The Commission has issued the enclosed Amendment No. 90 to Facility Operating License No. NPF-4 and Amendment No. 11 to Facility Operating License No. NPF-7 for North Anna Power Station, Units No. 1 and 2 (NA-1&2) respectively. The amendments are to become effective on **MAY 29 1981**

SUBJECT: VIRGINIA ELECTRIC AND POWER COMPANY, North Anna Power Station, Unit
Nos. 1 and 2

AMENDMENT TO FACILITY OPERATING LICENSE

Amendment No. 30
License No. NPF-4

Figure 6.2-1 Offsite Organization for Facility Management and Technical Support

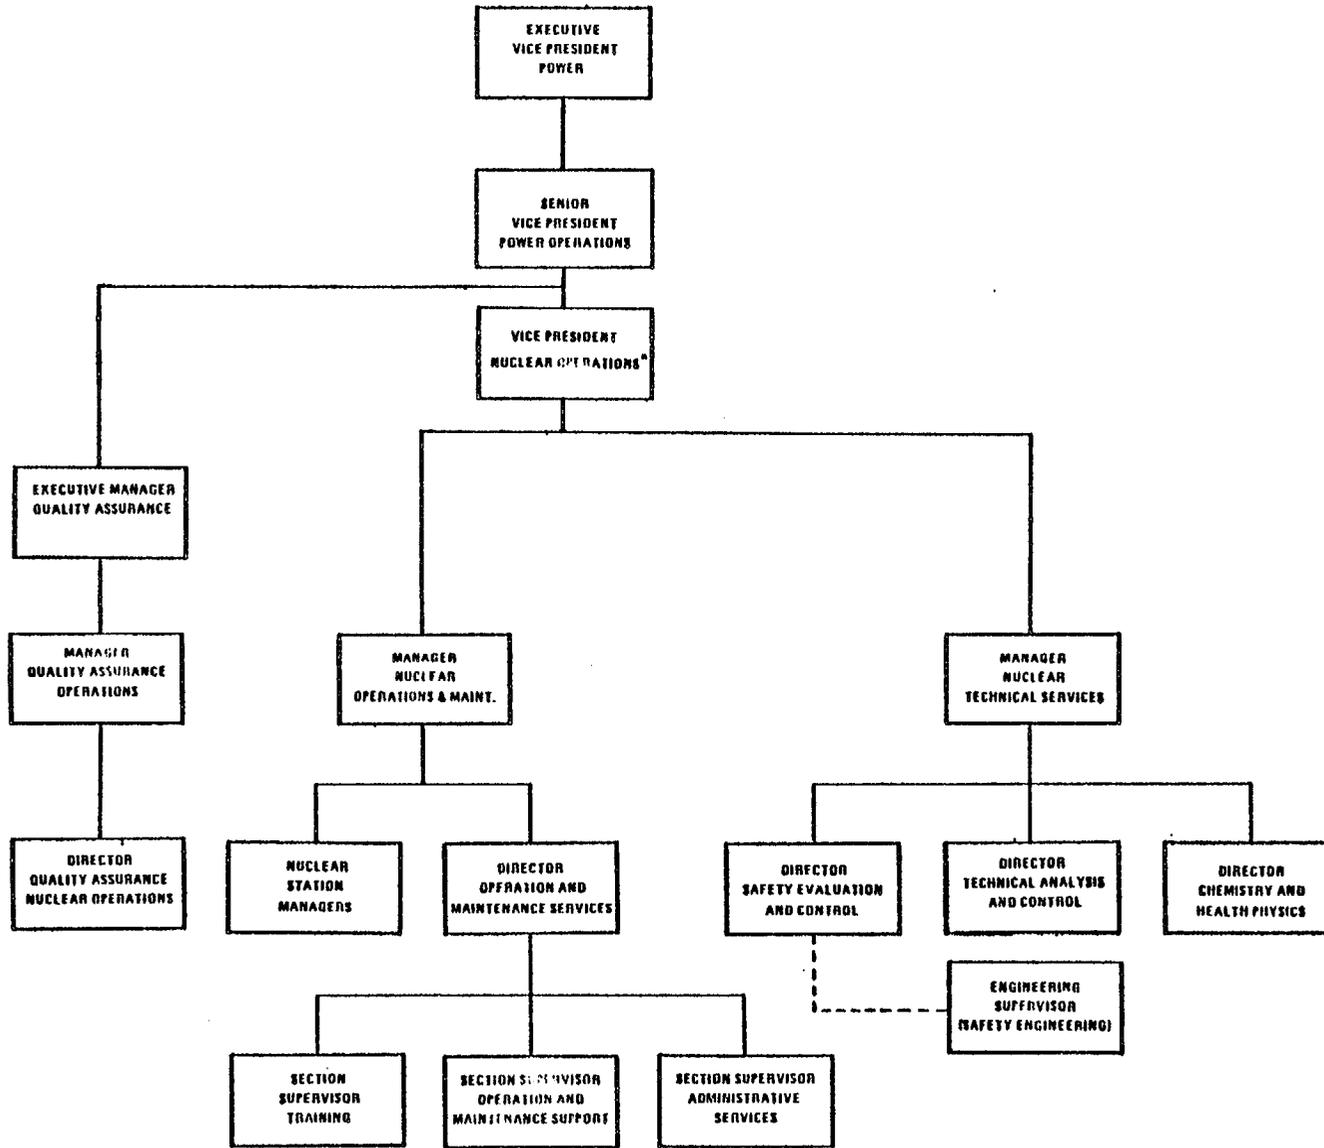
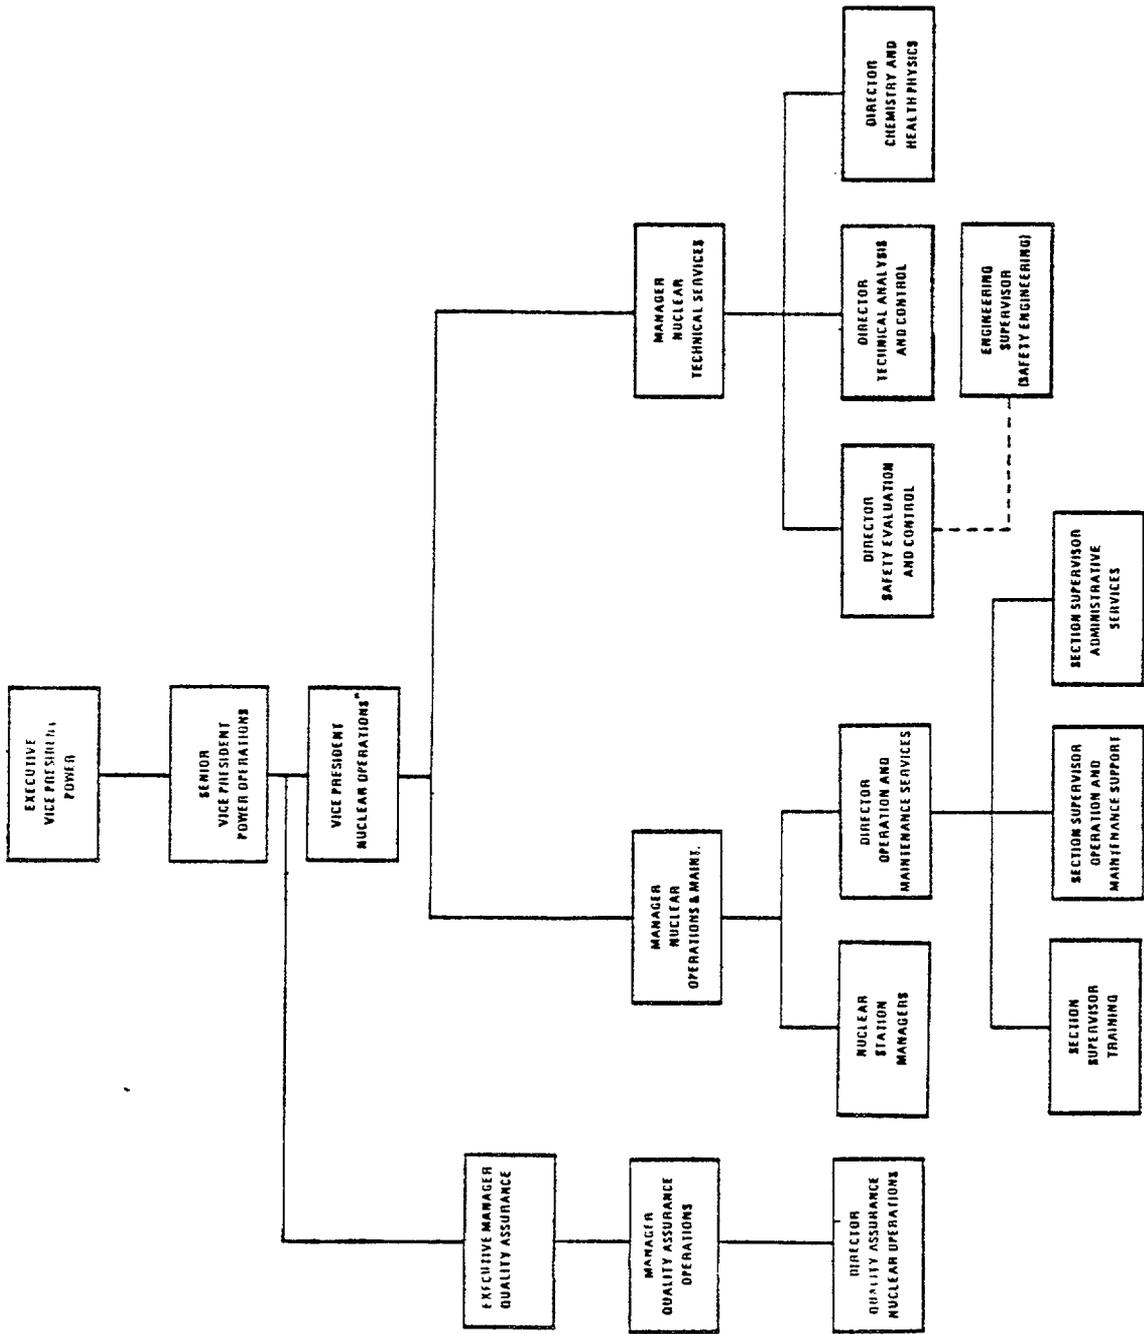
Technical Specifications Figure 6.2-1 has been revised to show the new structure of the offsite organization for facility management and technical support. The previous positions of Senior Vice President-Power and Vice President-Power Supply and Production Operations have been deleted from the Technical Specifications. The deleted positions have been replaced by the Executive Vice President-Power, the Senior Vice President-Power Operations, and the Vice President-Nuclear Operations. All previous references to the Senior Vice President-Power and Vice President-Power Supply and Production Operations positions have been revised to reference either the Senior Vice President-Power Operations or the Vice President-Nuclear Operations positions.

As indicated by Figure 6.2-1, the Manager-Nuclear Operations and Maintenance and the Manager-Nuclear Technical Services replace the previous position of Director-Nuclear Operations. Both managers will report to the Vice President-Nuclear Operations. The Manager-Nuclear Operations and Maintenance has responsibility for the supervision of the Nuclear Station Managers. Both Nuclear Station Managers and the Director-Operation and Maintenance Services report to the Manager-Nuclear Operations and Maintenance. The Section Supervisor-Training, the Section Supervisor-Operation and Maintenance Support, and the Section Supervisor-Administrative Services will report to the Director-Operation and Maintenance Services. Reporting to the Manager-Nuclear Technical Services are the Director-Chemistry and Health Physics, the Director-Technical Analysis and Control, and the Director-Safety Evaluation and Control.

Figure 6.2-2 Facility Organization - North Anna - Units 1 and 2

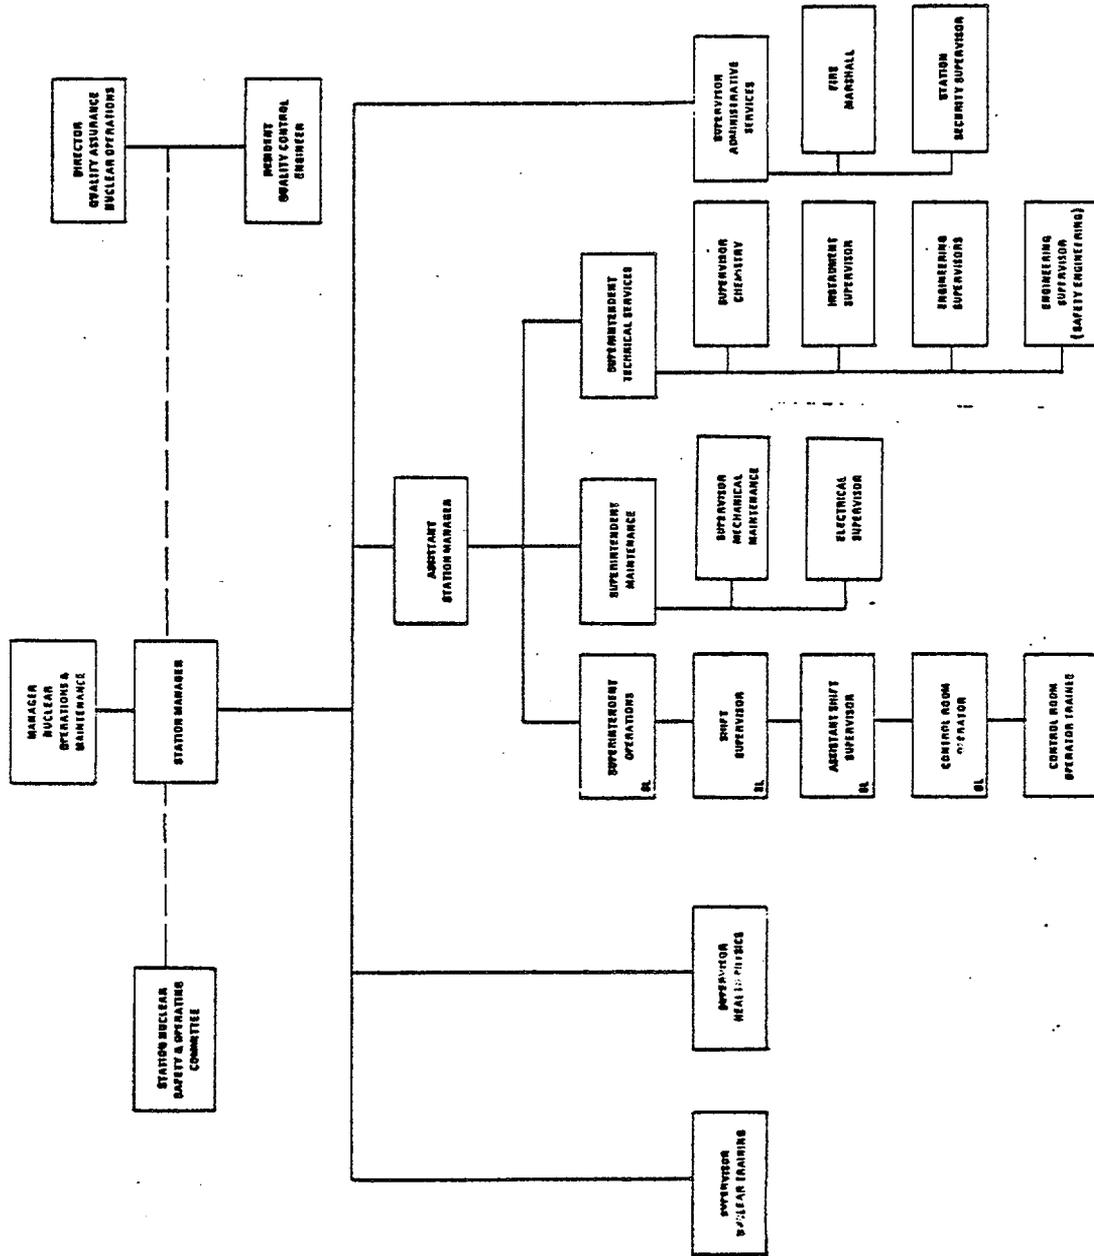
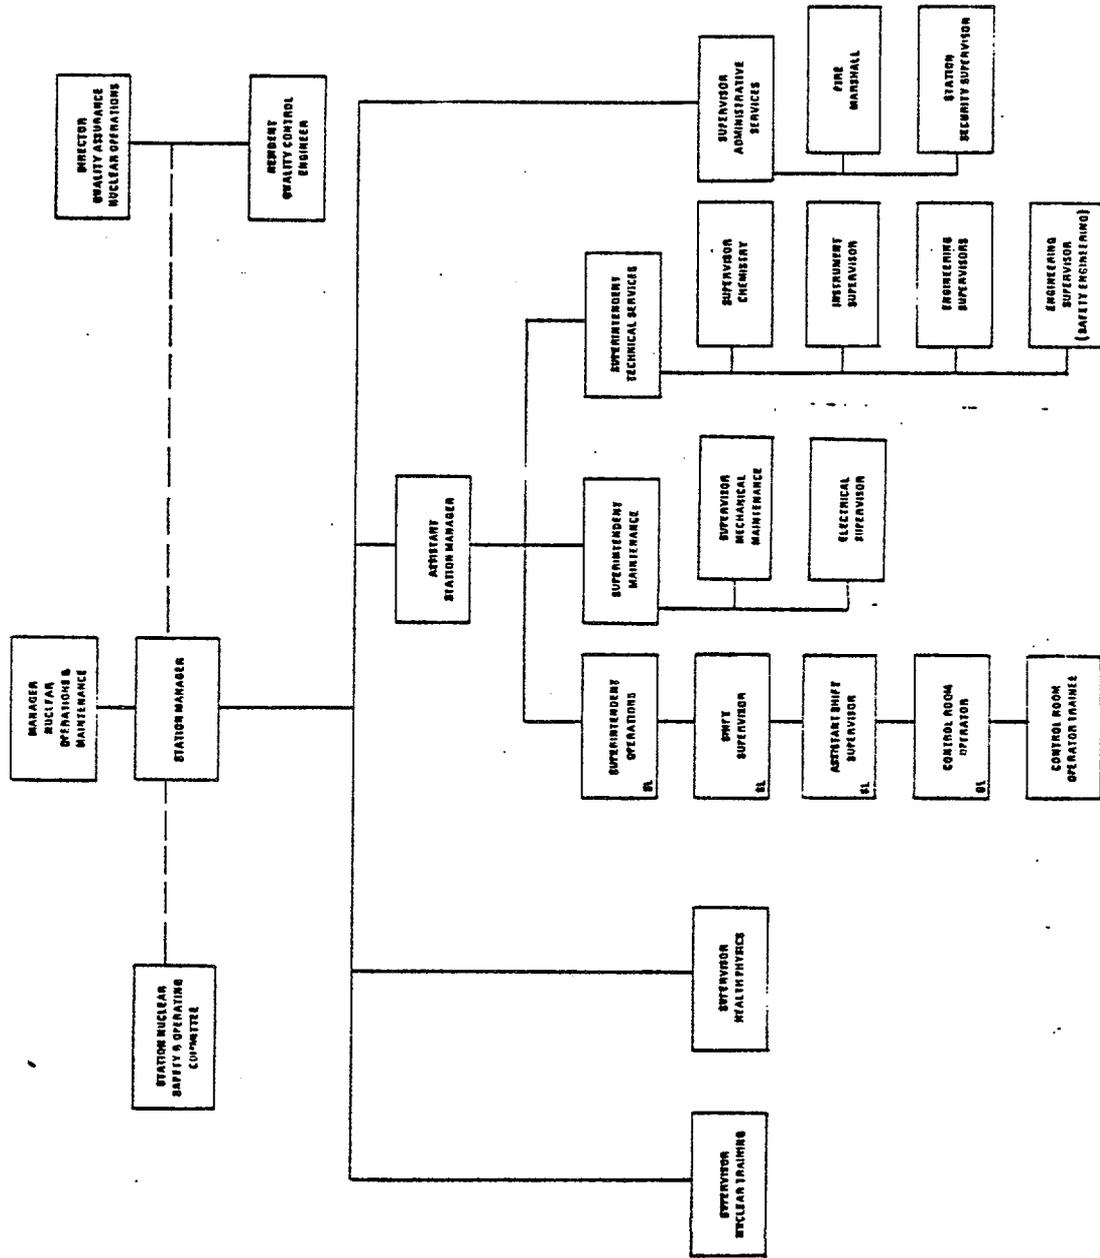
Technical Specification Figure 6.2-2 has been revised to show the new structure of the North Anna Power Station organization. As explained above, the Station Manager reports to the Manager-Nuclear Operations and Maintenance. The licensee's July 30, 1980 submittal (Serial No. 487) proposes revised Section 6.0 to add the new position of Assistant Station Manager to the North Anna Power Station organization. The Assistant Station Manager will be directly responsible for the safe operation and maintenance of the power station. He will serve in a coordinating capacity to the Station Manager, for the off-site activities of the Station. During the absence of the Station Manager the Assistant Manager will act as Station Manager. The Assistant Station Manager will also be the Vice Chairman of the Station Nuclear Safety and Operating Committee (SNSOC). The Superintendent-Operations, the Superintendent-Maintenance, and the Superintendent-Technical Services will report to the Assistant Station Manager. All three of these superintendents will remain members of the SNSOC.

The positions of Operating Supervisor and Auxiliary Operator have been eliminated from the organization chart. In addition, the position title of Assistant Control Room Operator has been revised to Control Room Operator Trainee. The positions of Maintenance Coordinator and Mechanical Supervisor have been replaced on the Station organization chart by the position of Supervisor-Mechanical Maintenance. Both the Maintenance Coordinator and the Mechanical Supervisor report to the Supervisor-Mechanical Maintenance. Other title changes made to the organization chart include the change of Supervisor-Safety Engineering to Engineering Supervisor (Safety Engineering), the change of Engineering Supervisor to Engineering Supervisors to reflect the two positions of Engineering Supervisor-Performance and Tests and Engineering Supervisor-Design Changes and Projects and, the change of Training Supervisor to Supervisor-Nuclear Training. The Supervisor-Health Physics position has been shifted such that he will now report directly to the Station Manager instead of reporting to the Superintendent-Technical Services. The positions of Supervisor-Nuclear Training and Supervisor-Administrative Services will also report to the Station Manager.

FIGURE 5.2-1
 ORGANIZATION CHART
 ENVIRONMENTAL TECH SPEC IMPLEMENTATION

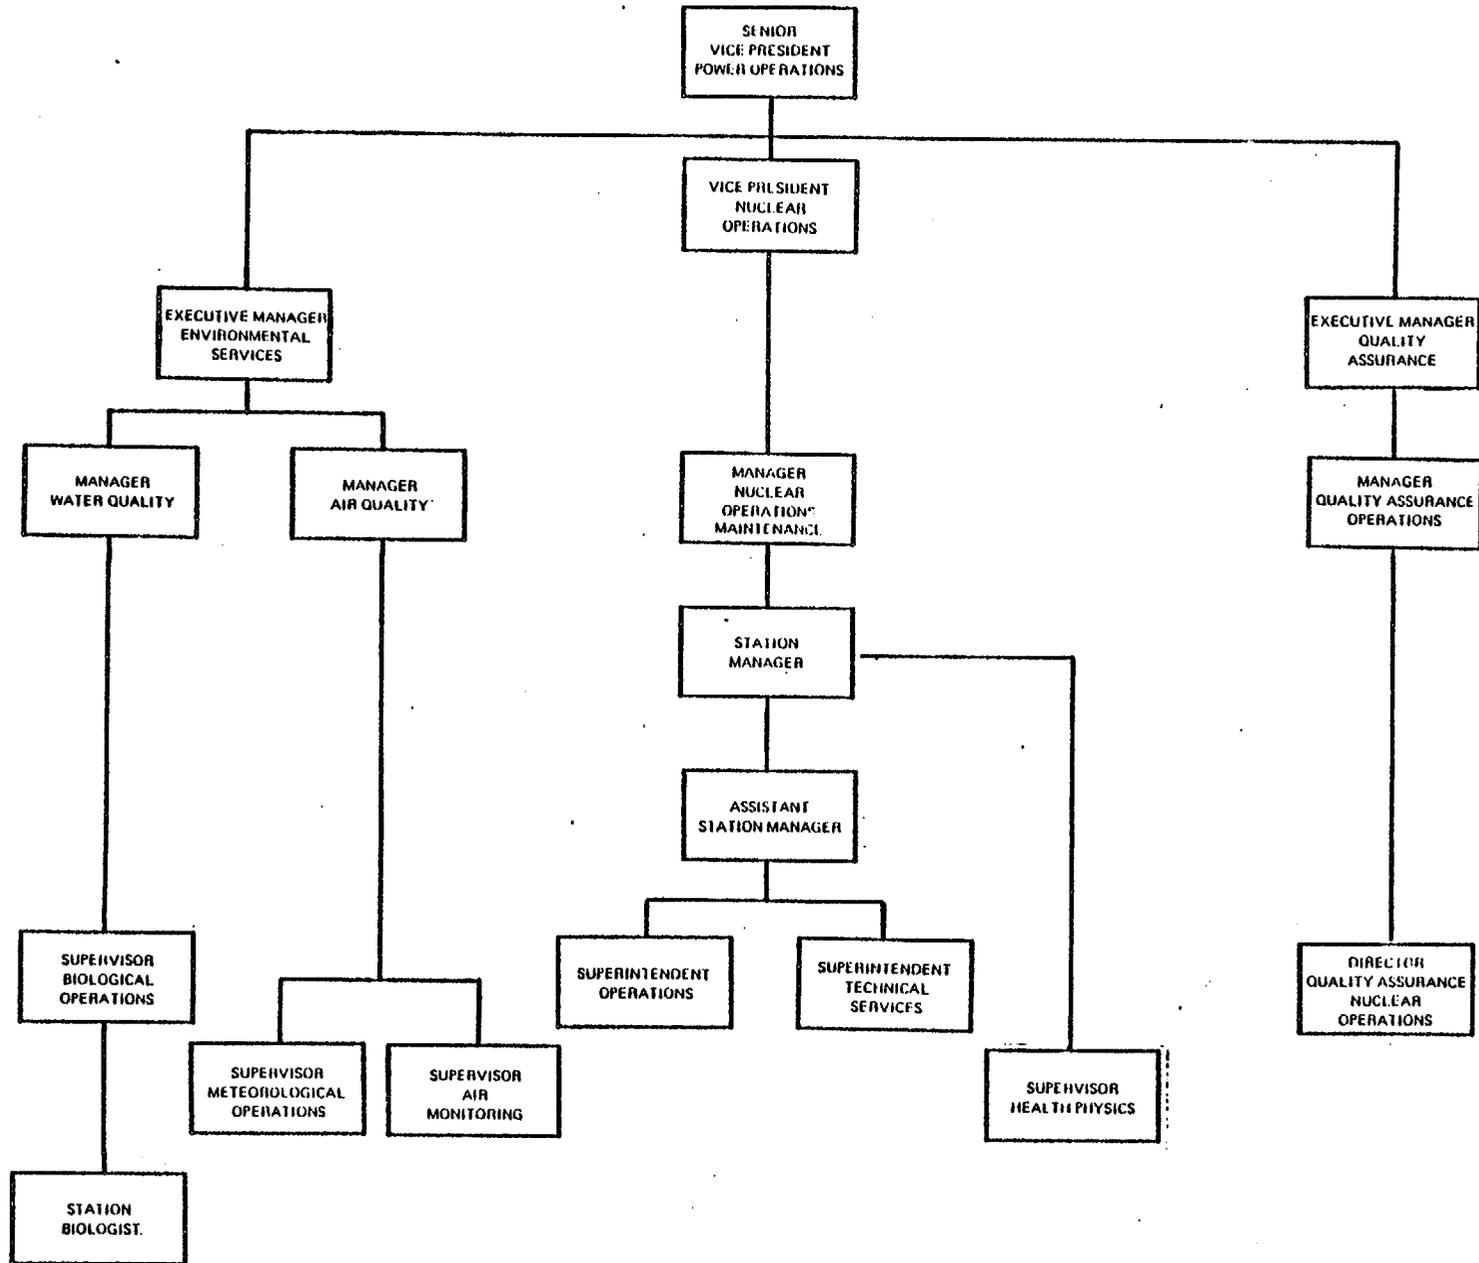
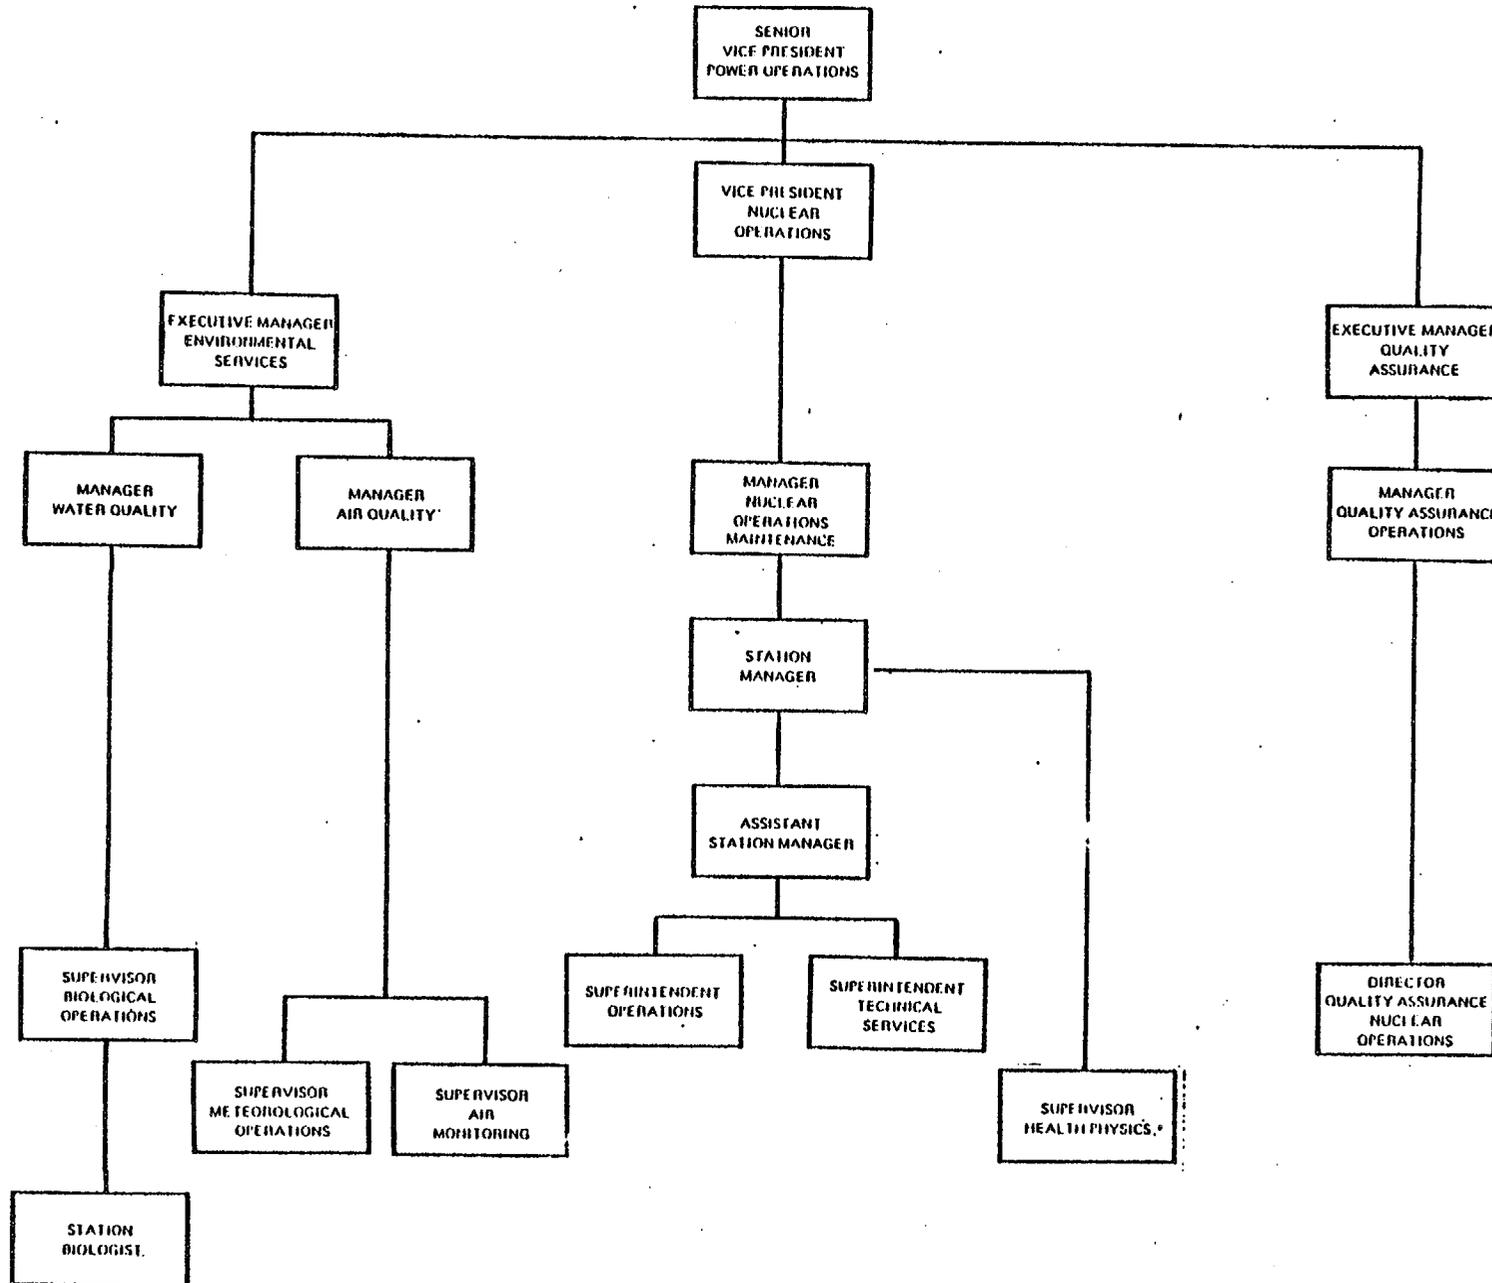
The organization charts for the North Anna Environmental Technical Specifications and the Appendix "A" Technical Specifications have been revised to reflect the restructuring of the Quality Assurance Department and changes to other organization titles. The previous title of Executive Manager-Licensing and Quality Assurance has been revised to Executive Manager-Quality Assurance. In addition, the positions of Manager-Quality Assurance, Operations and Director-Quality Assurance, Nuclear Operations are shown on the organization chart.
